Norwich to Tilbury

Document: 9.5 Proposed Change Application 1: Overview Report -
Change Request 1 (Bulphan) (CA1)

Final Issue CA1

March 2026

THE NATIONAL GRID (NORWICH TO TILBURY) ORDER
 PROPOSED CHANGE ORDER LIMIT PLANS - CHANGE REQUEST 1
 CURRENT PROPOSED PROJECT DESIGN ORDER LIMITS
 REGULATION 5(2)(o)
 SECTION H (SHEET A, THURROCK COUNCIL)

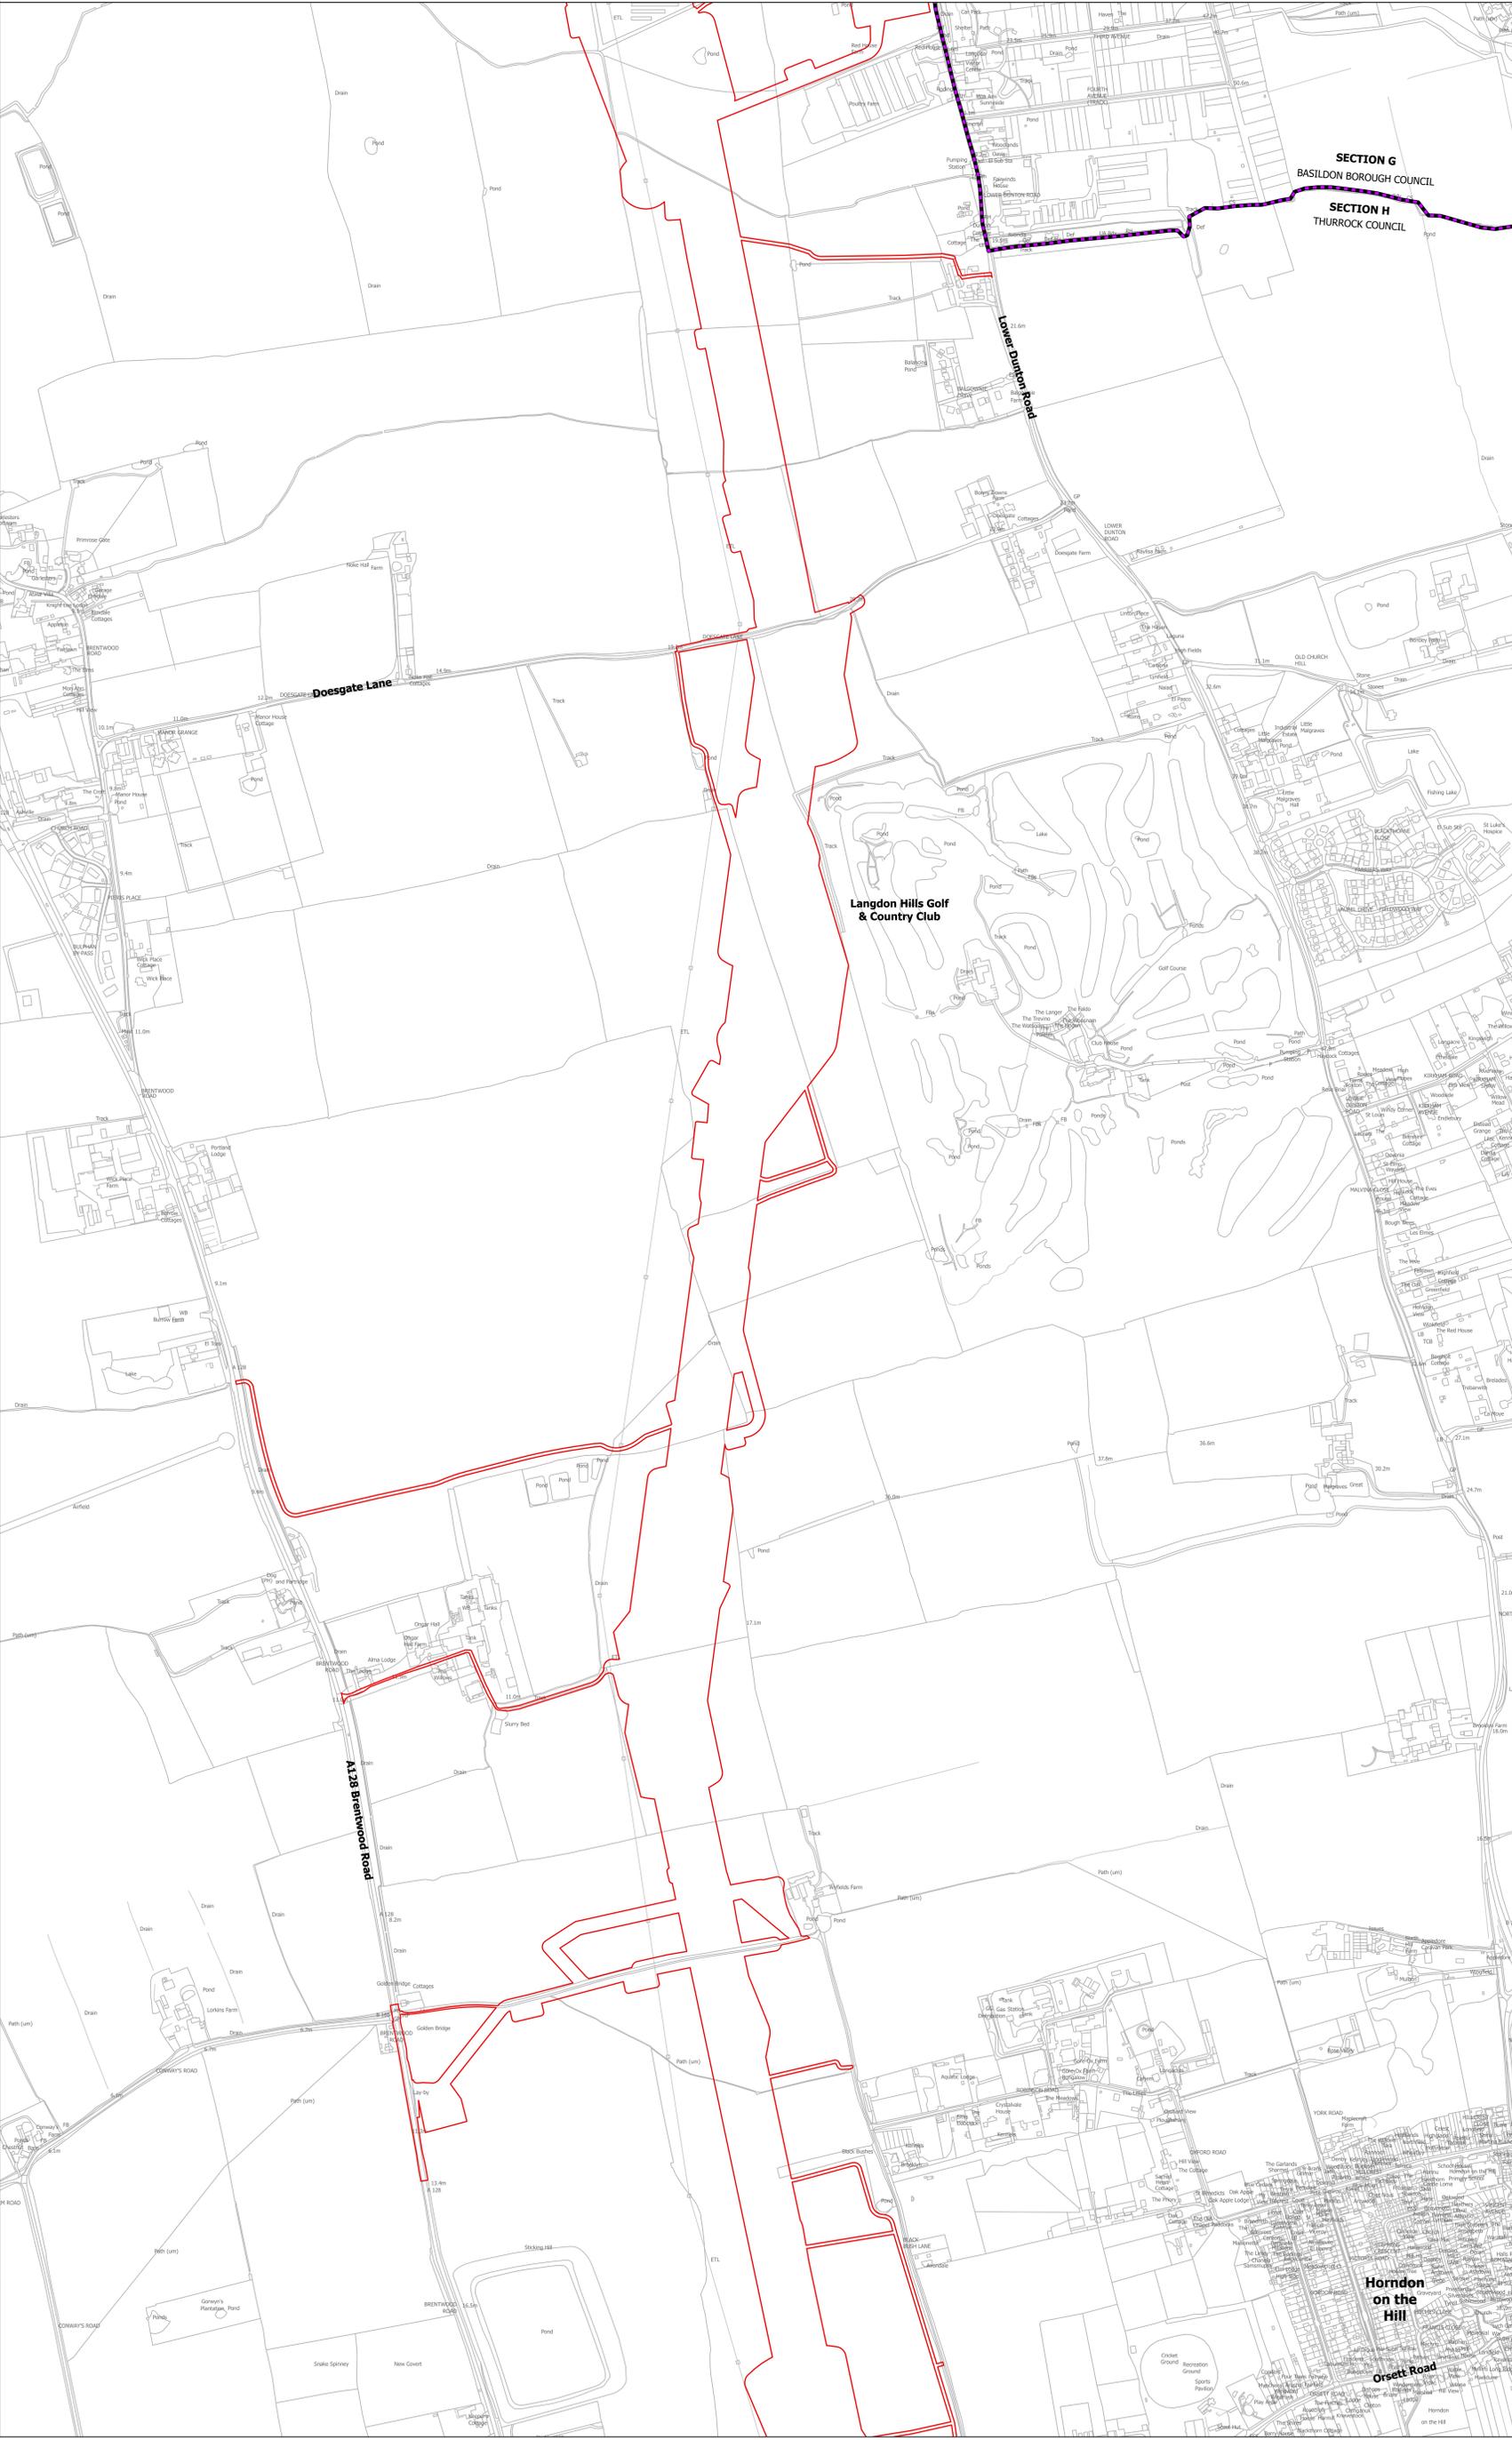
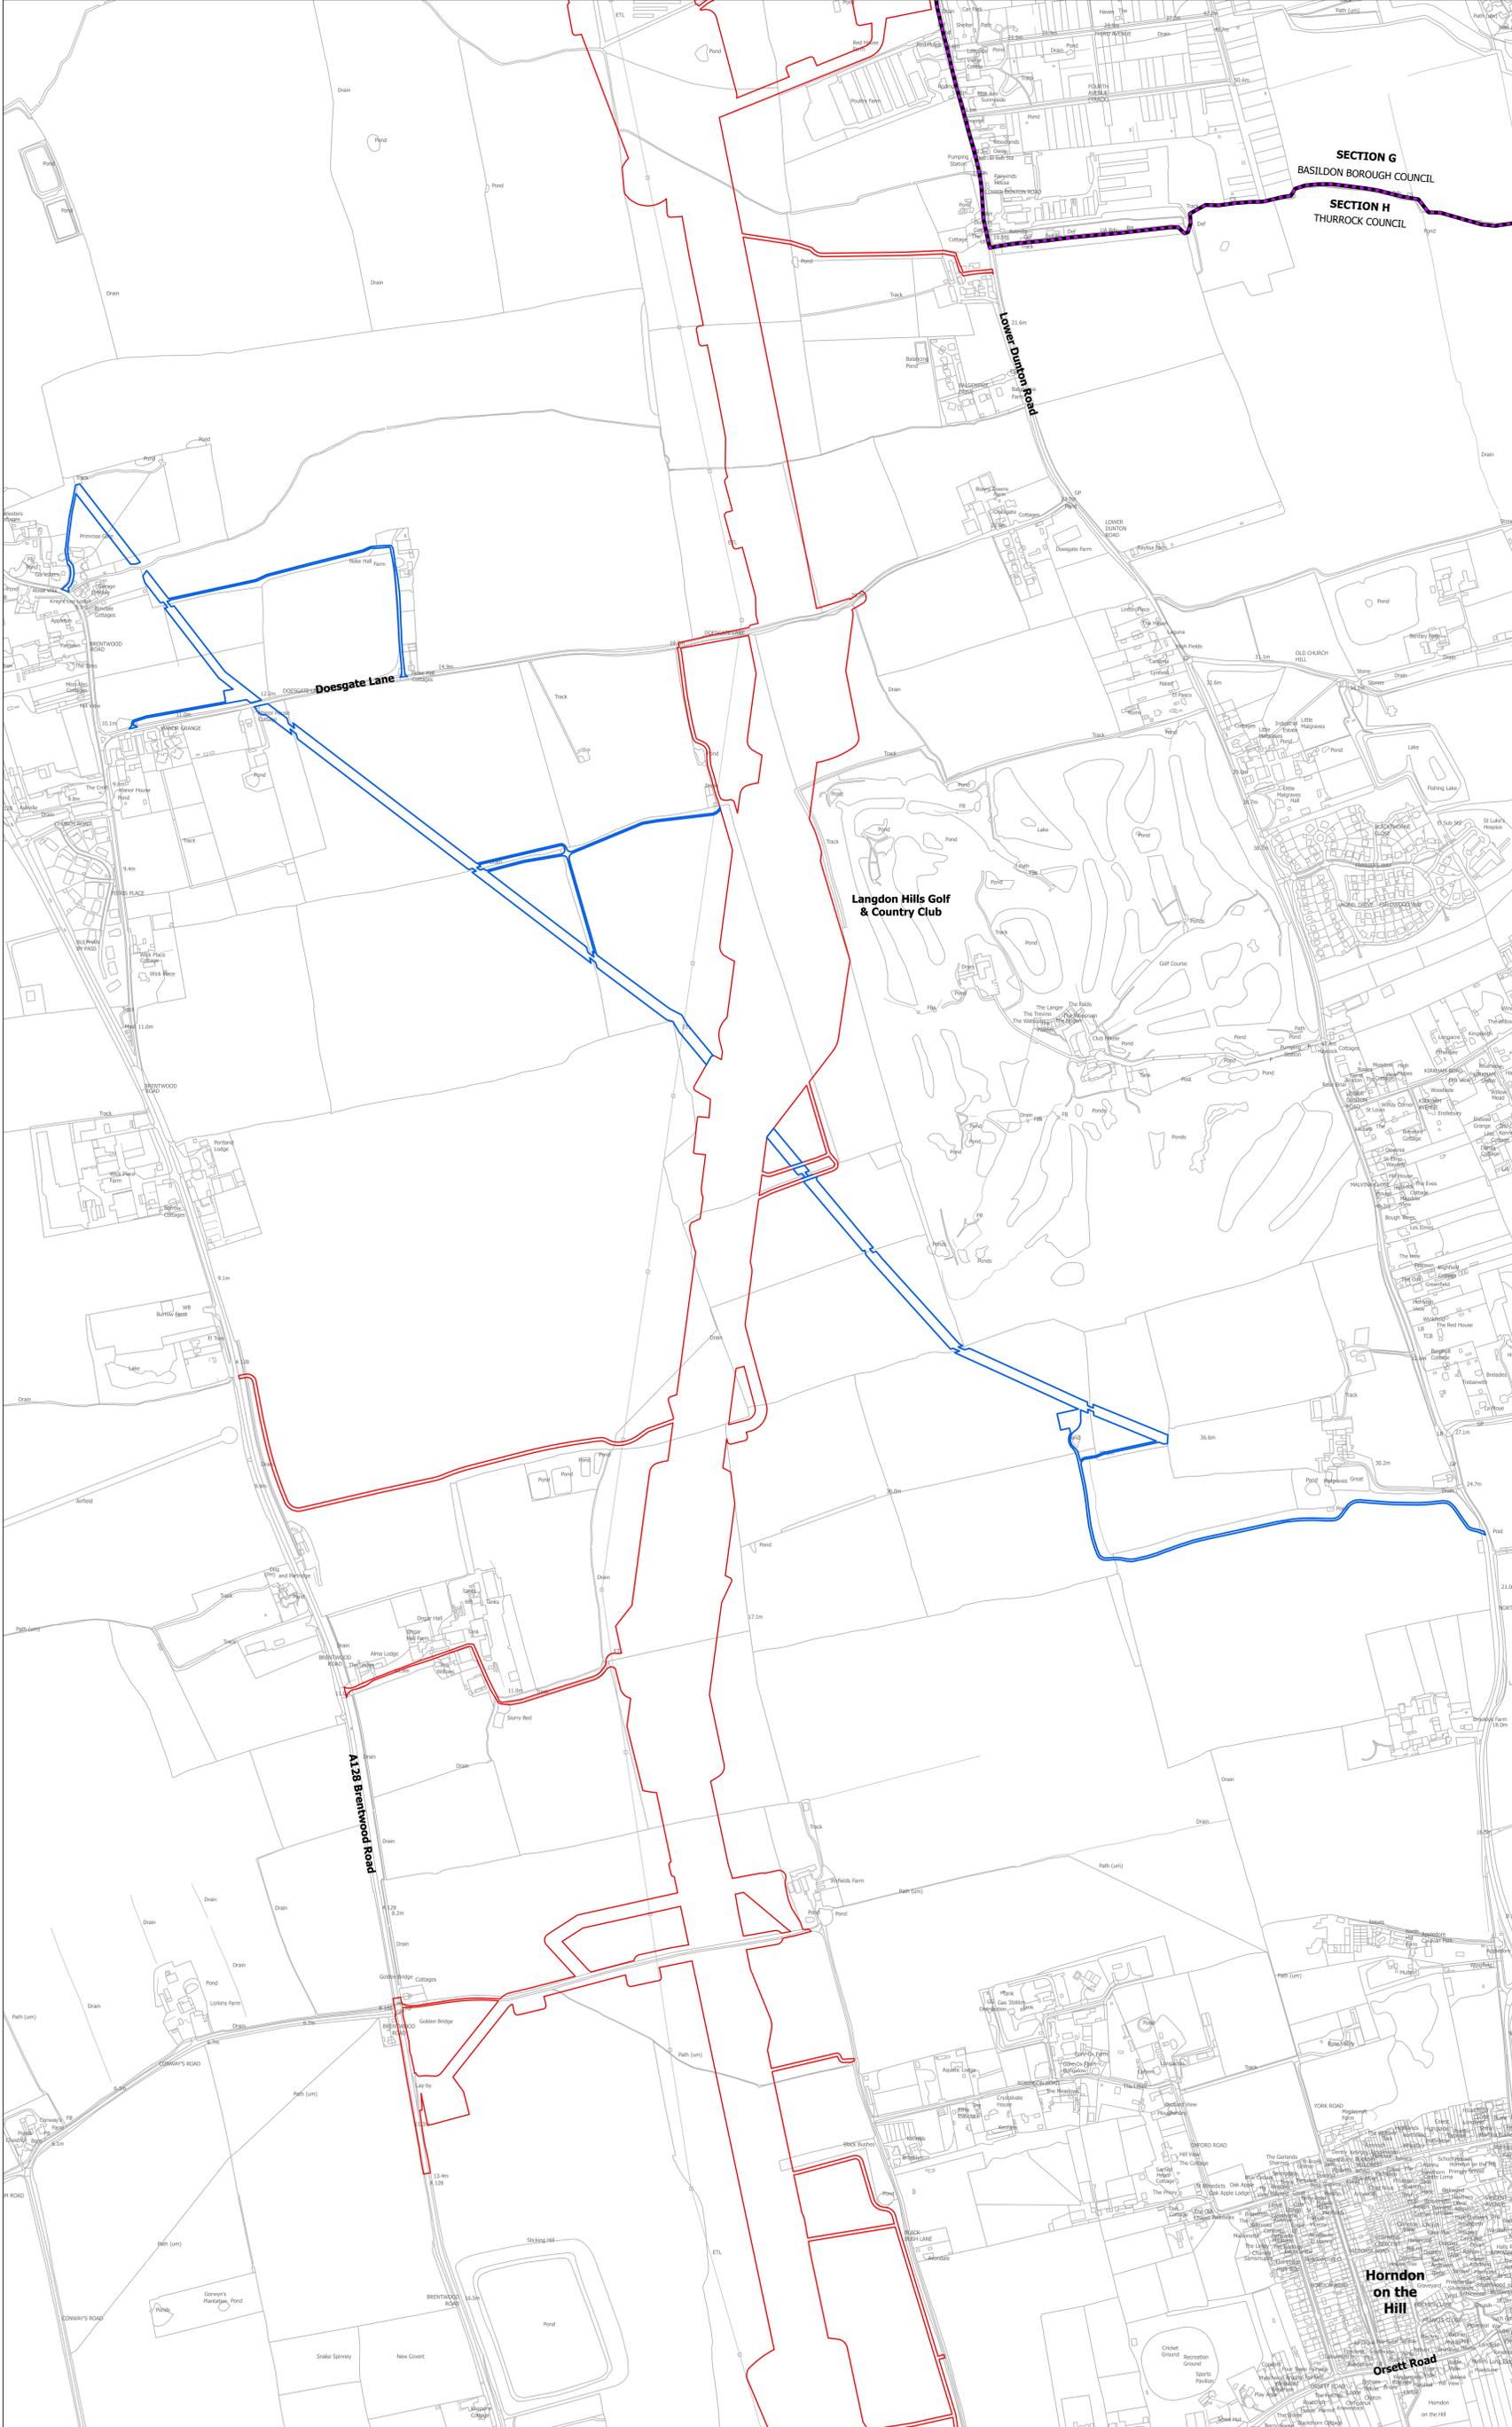
1.3.3 This document has been submitted to support Proposed Change Application 1 for Change Request 1 (Bulphan). Change Request 1 (Bulphan) relates to an increase in the Order Limits to facilitate works required for the protection of the existing Thames to Buncefield Multifuel Pipeline, west of Langdon Hills Golf Club. This proposed change responds to feedback concerning the potential for accelerated corrosion on existing buried metallic services received from the British Pipeline Agency Ltd (BPA) who act as the agent for the owner, United Kingdom Oil Pipelines Limited (UKOP). Further details about Change Request 1 (Bulphan) are provided in **Chapter 2** of this document.

- 2.1.3 Since submitting its application for development consent, the Applicant has continued engagement with the BPA as agent for UKOP (the owner of the Thames to Buncefield Multifuel Pipeline ('the Pipeline')). As a result of this engagement, the Applicant is proposing to incorporate a design change into the Project that seeks to address feedback raised by BPA in ongoing communication and within their Relevant Representation **[RR-0413]**. This design change is referred to as 'Change Request 1 (Bulphan)'. The change proposed applies to a very discrete geographical area of the Project and, as a consequence, the vast majority of the Project will remain entirely unchanged.

- 2.1.8 Change Request 1 (Bulphan) is considered necessary to avoid or minimise potential operational impacts of the Project on existing third-party infrastructure. This proposed change responds positively to feedback received from the BPA. It has been discussed and agreed by BPA.
